#### **Addendum 116 – Regulation No. 117**

#### **Revision 3 - Amendment 3**

Supplement 7 to the 02 series of amendments – Date of entry into force: 8 October 2015

#### **Uniform provisions concerning the approval of tyres with regard to rolling sound emissions and/or to adhesion on wet surfaces and/or to rolling resistance**

Figure 1

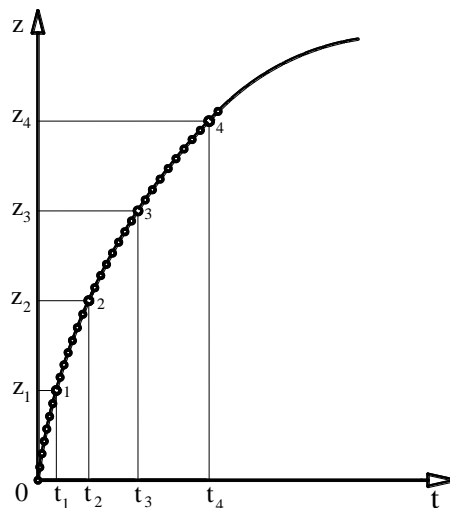
Insert a new Appendix 5, to read:

Deceleration method: Measurements and data processing for deceleration value obtaining in differential form  $d\omega/dt$ .

1. Record dependency "distance-time" of rotating body decelerated from peripheral with a speed range such as 82 to 78 km/h or 62 to 58 km/h dependent on tyre class (Annex 6, paragraph 3.2., table 1) in a discrete form (figure 1) for a rotating body:

2. Approximate recorded dependency by continuous, monotonic, differentiable function:
  - 2.1. Choose the value nearest to the maximum of  $z$  dividable by 4 and divide it into 4 equal parts with bounds:  $0, z_1(t_1), z_2(t_2), z_3(t_3), z_4(t_4)$ .
  - 2.2. Work out the system for 4 equations each of the form:
